INDESIT company

Model type:
AT64EX

Commercial code:
F027674

FIG. 1

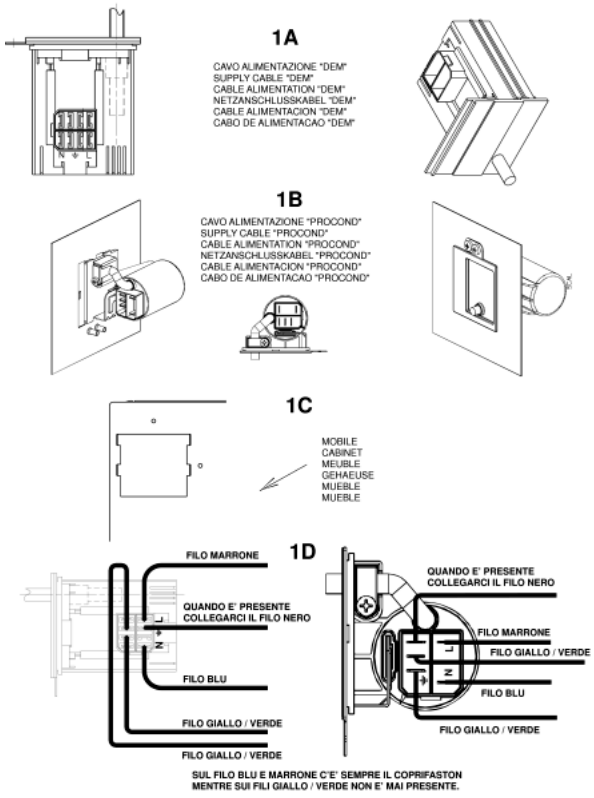
n1040288: Power supply cable + moulded filter on top-load Brembate WMs

From serial number 30224.0001, all top-load washing machines produced in the Brembate factory have been equipped with a new power supply cable with moulded filter and new rear panels with a specific opening for fixing the new cable.

To use premodified wirings on modified products perform the connection to the terminal block of the new cable as shown in fig. 1 - 1D.
The wiring diagrams indicated in the Documentation remain the same.

N1040309FIG1

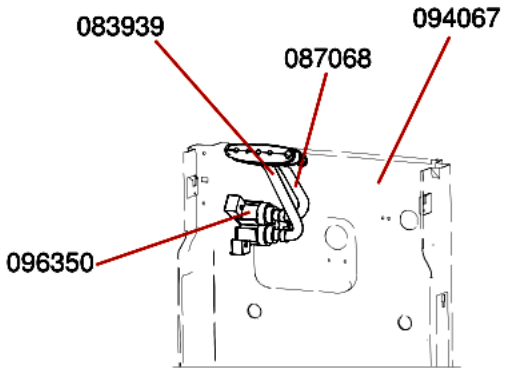
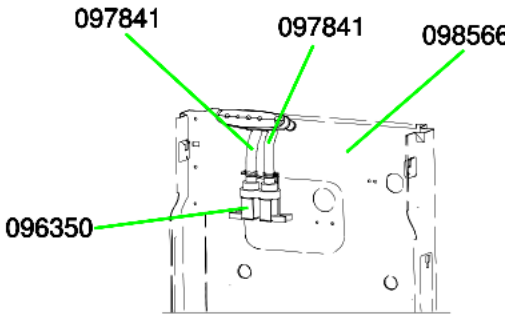
n1040309: Modification of rear panels on TOP LOADING washing machines.

From serial no. 30912.0001, the system used for fixing the loading solenoid valve (spare part code 096350) to the rear panel has been modified on Top Loading washing machines, rotating its position by 90°.
The solenoid valve (spare part code 096350) has been modified with the 45° rotation of a coil; the Replacements Warehouse will continue to manage this part with the same code. When replacing on premodification machines, fit the coils as shown in figure N1040309FIG3-1 and on modified machines, as shown in figure N1040309FIG3-2; to rotate the coil, lift it using a screwdriver and then refit according to the inserts on the plastic.

Replacement codes of the parts affected by this modification (see figure N1040309FIG1):

FIG1 A - PREMODIFICATION STRUCTURE
solenoid valve tube/distributor assembly: premodification 083939;

solenoid valve tube/distributor assembly: premodification 087068;
rear panel: premodification 094067.
FIG1 B - NEW STRUCTURE
solenoid valve tube/distributor assembly: new 097841;
solenoid valve tube/distributor assembly: new 097841;
rear panel: new 098566.

Premodification panels will be managed by the Replacements Warehouse while stocks last; when replacing with new ones on premodification appliances the new tubes must also also be used.
When using the new panels on appliances before serial no. 30609.0001, fitted with solenoid valve code 083940, rotate the coil 45° and follow the instructions given above for code 096350, paying attention during the wiring phase to keep the cables away from the bowl support spring.

N1040309FIG2

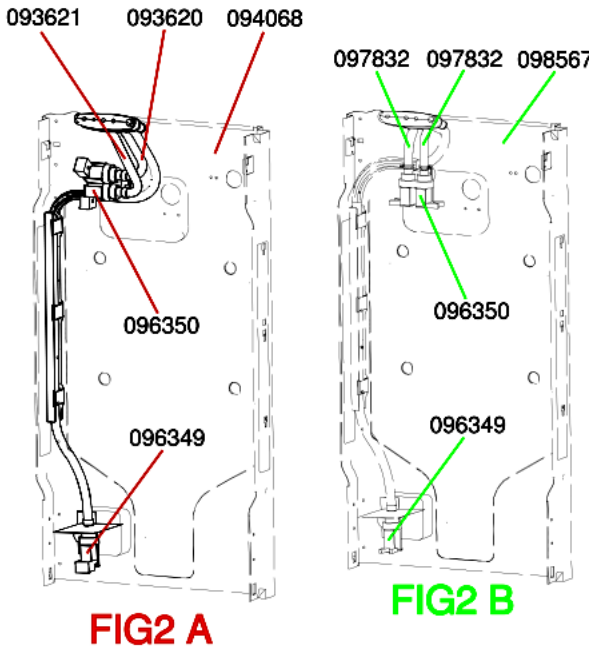
Replacement codes of the parts affected by the modification to WMTL80UK (see figure N1040309FIG2):

FIG2 A - PREMODIFICATION STRUCTURE
solenoid valve tube/distributor assembly: premodification 093620;
solenoid valve tube/distributor assembly: premodification 093621;
rear panel: premodification 094068.
FIG2 B - NEW STRUCTURE
solenoid valve tube/distributor assembly: new 097832;
solenoid valve tube/distributor assembly: new 097832;
rear panel: new 098567.

n1040321: Plastic protecion for solenoid valve.

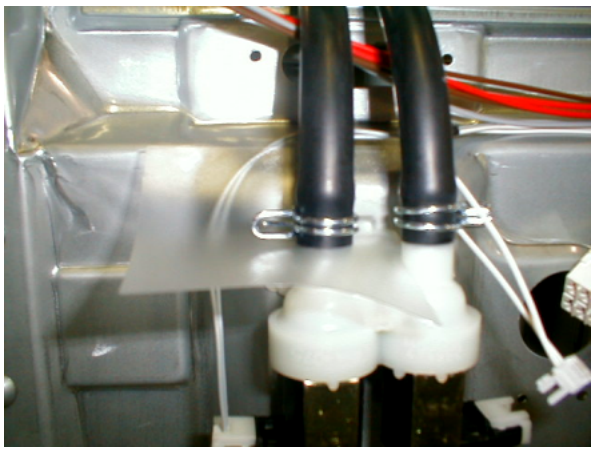
All top-load washing machines produced from September 2003 to February 2004 (from serial no. 30900.0000 to 40300.0000) have been equipped with a plastic protection Service code 109798 (shown in N1040321FIG1), to prevent water from damaging the solenoid valve and electronic card.

N1040324FIG1

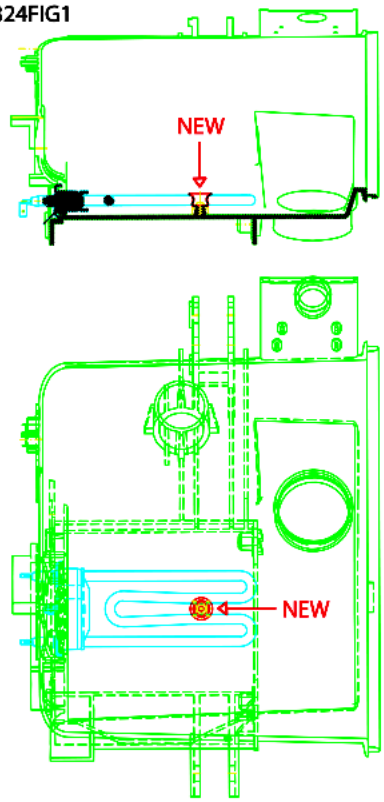
n1040324: Modification of heater fixing system on top-load washing machines.

From serial number 40506.0001, the fixing system of the heater to the tank has been modified on all top-load washing machines affected by this note, with the introduction of a metal retainer (image N1040322FIG1 reference NEW) in place of deflector Service code 055322.

The modification has involved both heater and tanks. Given below are the Service codes of the new and old items concerned:

-PLASTIC TANK FOR 600-1000 RPM MACHINES: new 110152, premodification 083805;

-PLASTIC TANK FOR 1200 RPM MACHINES: new 110153, premodification 092023;

-HEATER: new 110148, premodification 083906.

n4009a02: Motor fixing changed on Top Loading washing machines

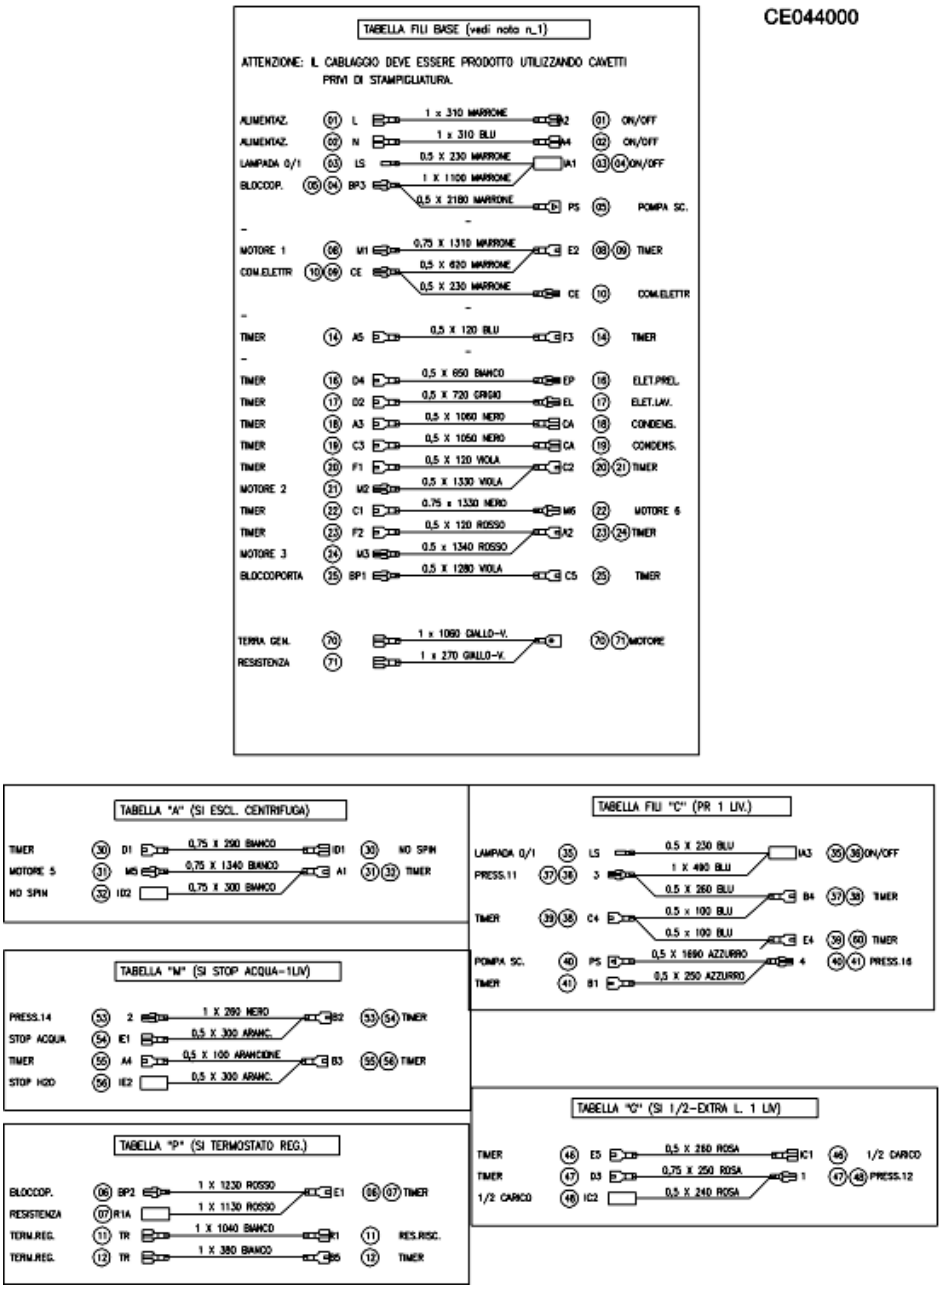
Top Loading washing machines have changed the fix of motor to the tub.
The tub design is changed in the motor fixing side and two new screws code C00268497 are introduced instead of the old screws C00084333 and the old nut:

C00266015 nut of products with Triphase motor;

C00258673 nut of products with Collector motor.

In assistance on premodification products with the new tubs, you have to fix the motor using the new screws C00268497 instead of the screws and nut that you find in the product.
